Re: Request for TEDS Exemption for Access Offsets, Spacing & Minimum Corner Clearance 2850 North Avenue

Re: Design Exception #DE03-06 - 2850 North Ave. (old Shell Convenience & Gas

DESIGN EXCEPTION #3-06

DE# 3-06 2850 North Ave. Driveway Spacing

EXISTING 2850 NORTH AVENUE SITE

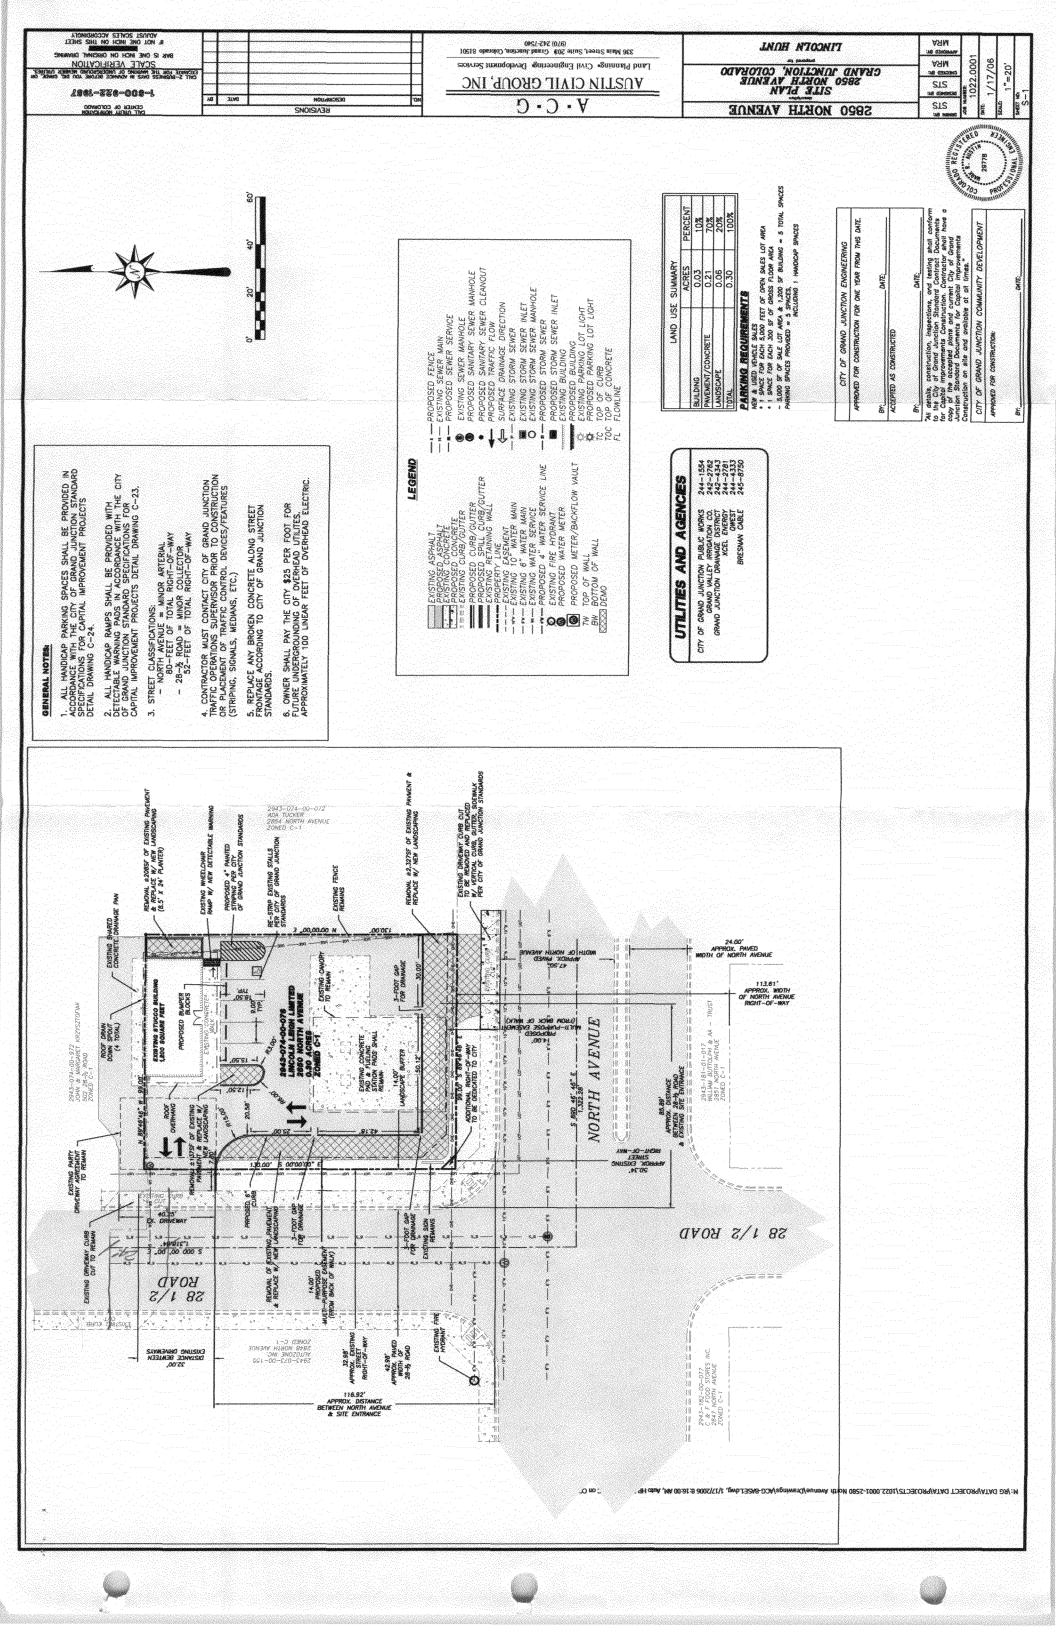
Scott Sorensen, Austin Consulting Group has submitted aTEDS Exception on behalf of his client Lincoln Lee Limited. "Lincoln Leigh Limited is proposing to convert the old Shell Convenience and Gas Station into a vehicle sales lot." The existing driveway into the property off 28 ½ Rd. does not meet the 50' offset requirement for driveways on opposite sides of a local collector roadway (the two driveways provide approximately 24 feet of separation, center of drive to center of drive) or the requirement that driveways provide a minimum of 150' of corner clearance from the nearest signalized intersection (the south edge of the driveway is approximately 110 feet north of the flowline in North Ave.).

Staff recommends approval of the exceptions requested for the 28 $\frac{1}{2}$ Road access point – Corner Clearance and Offset Spacing. The preferred alternative would be to move the driveway north to align with the existing driveway to the west with Auto Zone.

Please find attached the committee's decision for the above referenced request. This design exception has been approved as requested. You may use this decision to proceed through the development review process for this exception.
